From: admin pa
Sent: 23/05/2024 11:47:15 AM
To: Council Northernbeaches Mailbox
Cc: [REDACTED]
Subject: TRIMMED: DA2024/0487 - Address 139 Lagoon Street Narrabeen
Attachments: Report of MTK Consulting dated 16 May 2024.pdf; Email letter 23.05.2024 to Northern Beaches Council.pdf;

Re: Comments on the proposed garage at 139 Lagoon Street, Narrabeen

As instructed, we have reviewed the documents associated with the proposed alterations and additions to the residence at 139 Lagoon Street, Narrabeen. The brief is specific to the impact of the proposed works on the driveway of 141 Lagoon Street, Narrabeen. The purpose of the review is to assist the Town Planner with a response to the proposed development.

MHDP Proposed Garage Floor Plan #2122/A101/A dated 16/1/2024

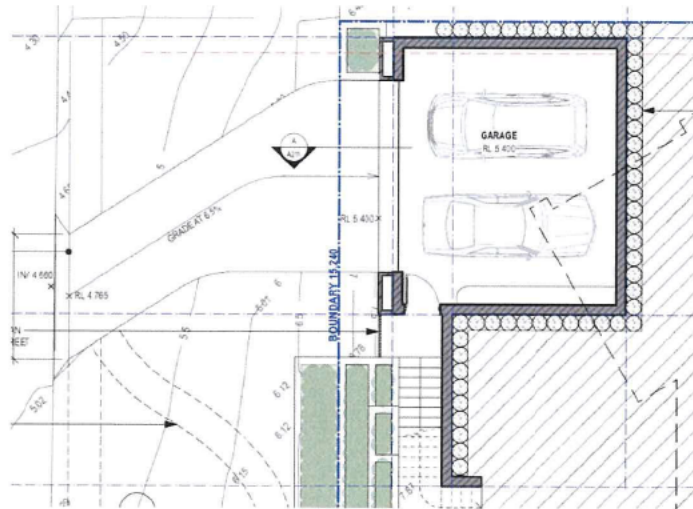
The ground level to the northwestern corner of the site, at the boundary between 139 and 141 Lagoon Street appears to be approximately RL 6.0m. The garage floor level is at RL 5.40. The excavation therefore will be at approximately RL 4.90m to comply with the Geotechnical requirements included in the submission to Council.

The Garage has a nominal offset to the boundary of only 450mm. This important information is only nominated on the ground floor plan #2122/A100/A. This measurement should also be included on the Garage Floor Plan #2122/A101/A.

The contiguous piles indicated on the plans have been suggested to be outside the alignment of the structure for the garage. The contiguous piles should not be installed any closer than 200mm to the boundary to allow for the provision of a boundary fence between the two properties on completion of the works.

The planter (to the northern and western boundary of the development site) and the associated footing extend into the corner of the site with 0.0m offset to both the front and side boundaries. There is an unacceptable level of risk to the driveway of 141 Lagoon Street without the possibility of shoring due to the zero-offset proposed in the plans.

The existing building within the footprint of the excavation and proposed shoring will likely be demolished to carry out the works and reduce site risks during construction.

MHDP Photomontage #2122/SK10/A dated 16/1/2024

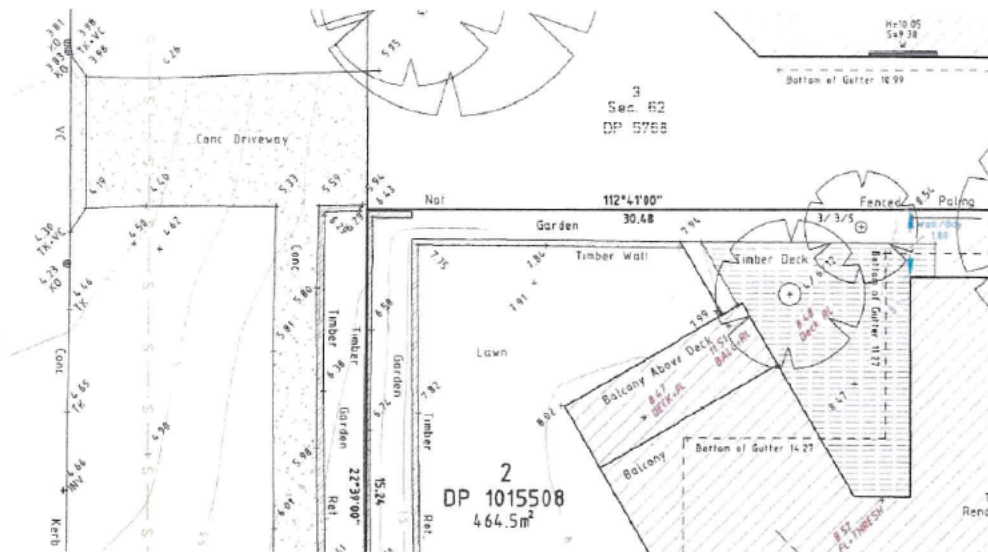
The ground level to the corner of the site boundary between 139 and 141 Lagoon Street appear to be approximately RL 6.0m. The garage floor level is at RL 5.40m. This is a 600mm difference in the levels at the boundary location.

The impression presented in the documentation does not represent the proposed form along the street frontage and within the Councils Road reserve. The garage level is approximately 600mm deeper into the ground which will increase the bulk of the garage from the street. The inclusion of the retaining walls along the alignment of the side boundary driveway with 141 Lagoon Street should also be corrected.

There is no inclusion of the proposed planter and the effect on the driveway of 141 Lagoon Street in the Photomontage. This is apparent as indicated on the Lagoon Street Elevation, #2122/A201/A dated 16/1/2024.

Survey by Burton & Field #E7194-86262 issue A, dated 13/11/2023

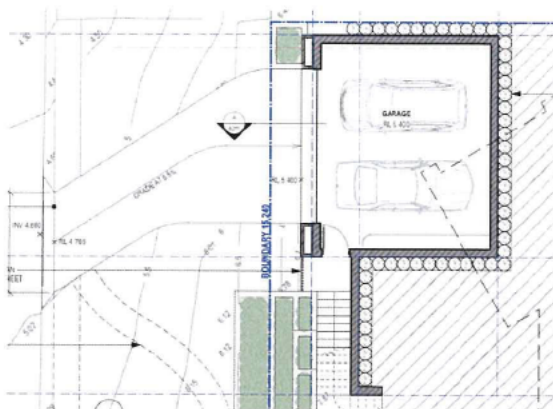
The Survey along the common boundary between 141 & 139 lagoon Street does not include the ground surface levels of the neighbouring site to the proposed development.

There is a critical failure of the gathering of the information to provide an informed opinion regarding the expected levels of ground and finishes that would need to be supported by the contiguous piles (or alternative shoring) during the construction phase.

Without the ground levels nominated and included in the documentation, the true extent of the works and therefore the appropriate design is not possible.

Council should insist on the levels of 141 Lagoon Street to be included on the survey with the application to verify or correct the assumptions made in the documents listed within our review. Furthermore, a suitable design for the support of the neighbouring properties must be included in the application where the proposed garage is within the side boundary setback required by Council in the Development Control Plan.

MHDP #2122/A101/A Proposed Garage Floor Plan dated 16/1/2024

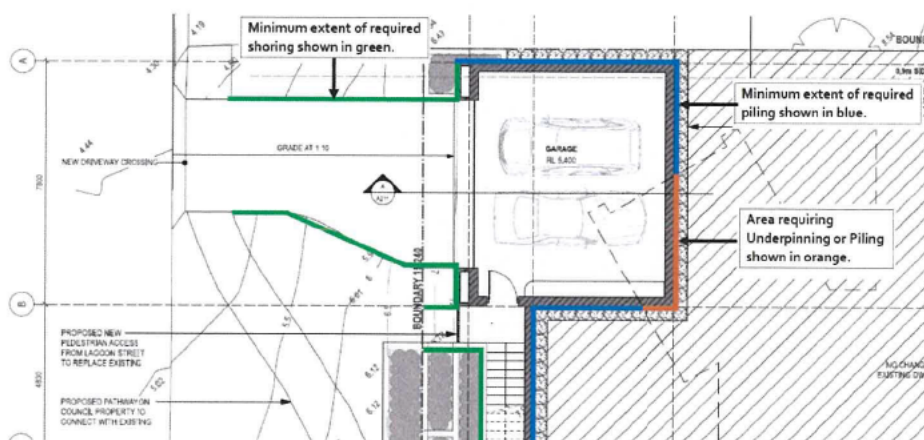
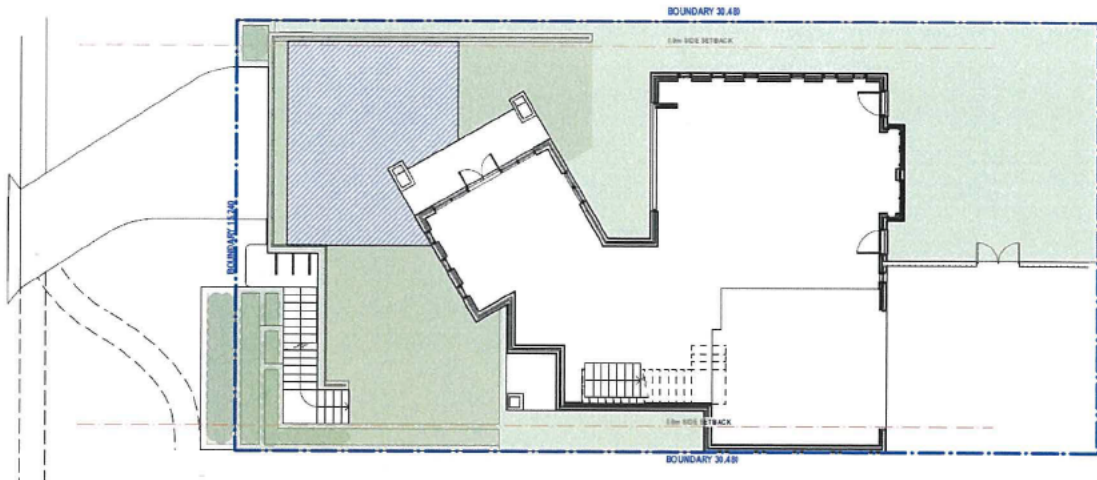
The proposed ground floor plan in the Architectural set has the same drawing number, revision and date as the drawing used in the Geotechnical Engineers reporting however the extent of the planter boxes and the driveway alignment are different.

The Council should insist that the Application be resubmitted with the corrected Architectural set and inclusions in the Geotechnical Engineering reporting. There should not be two different versions of the same drawing in the Application to Council.

The plans and details must also include the relative levels of the northern neighbour's driveway due to the critical involvement of the parameter for the shoring design along that boundary. We note that even with a compliant side boundary setback, shoring will be required for the excavation as defined by the Geotechnical Engineer.

WGG Reporting #J5243 dated 18th January 2024

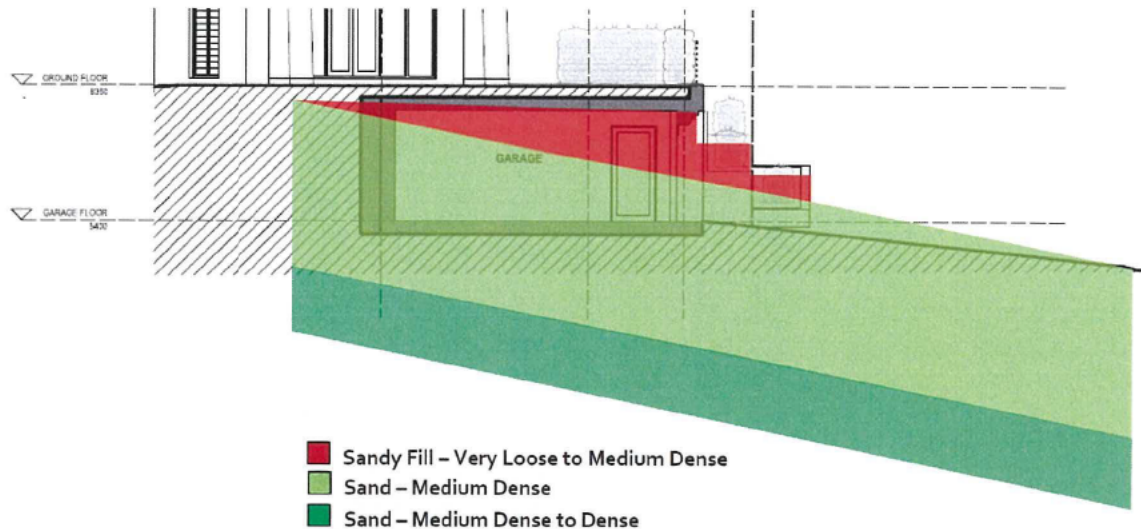
The White Geotechnical Group indicates the following within the reporting. Without the levels of the neighbouring driveway along the length of the northern boundary of the development site, the estimation of the depth for the excavation is not an accurate quantity.

The description of the works should also address that the garage is located along the northern boundary of the development site.

There should have been an insistence/requirement by the Geotechnical Engineer and the Architect that the finished levels of the driveway to 141 Lagoon Street, Narrabeen be included in the Survey used for the proposal.

Sectional details for the proposed works should have been included to define the extent of the involvement and works required to ensure the stability of the neighbouring site. The detailing would assist in the planning for the shoring, inclusion of services (if possible) and the understanding that plants will not grow over the shoring system (nominated contiguous piles for example).
